Massachusetts Department of Transportation, Highway Division

SUPPLEMENTAL SPECIFICATIONS

FEBRUARY 25, 2010

FIGURE 1

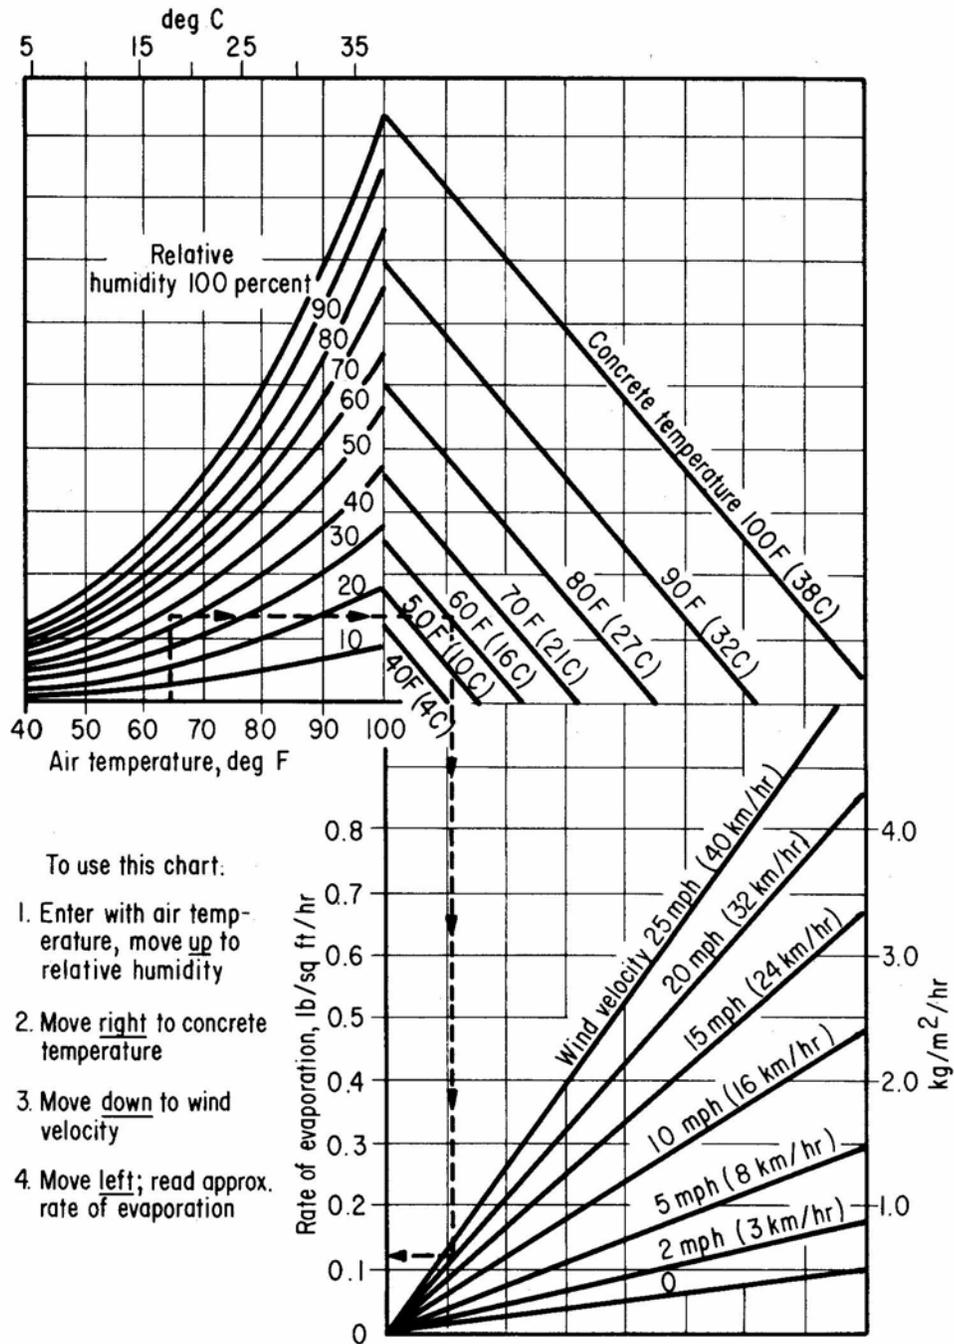
Screed rails shall be set entirely above the finished surface of the concrete and shall be supported in a manner approved by the Engineer. Where stud type shear connectors are available, welding to the studs will be permitted. Where no studs are available, other means of attaching the screed rail supports shall be provided. No welding will be permitted directly on stringer or girder flanges or cover plates in tension areas, nor in areas subject to stress reversal, for attaching either screed rail supports of any type. Any welding in compression areas shall be approved by the Engineer.

Screed rail supports set in the concrete shall be so designed that they may be removed to at least 2 inches (50 mm) below the surface of the concrete. Voids created by removal of the upper part of the screed rail supports shall be filled with mortar having the same proportions of sand and cement as that of the slab or wearing surface. The mortar shall contain an approved additive in sufficient proportions to produce non-shrink or slightly expansive characteristics. Screed rail supports shall not be treated with parting compound to facilitate their removal. Rails for finishing machines shall extend beyond both ends of the scheduled length for concrete placement. The extended length shall be of sufficient distance to allow finishing machine(s) to clear the concrete to be placed.
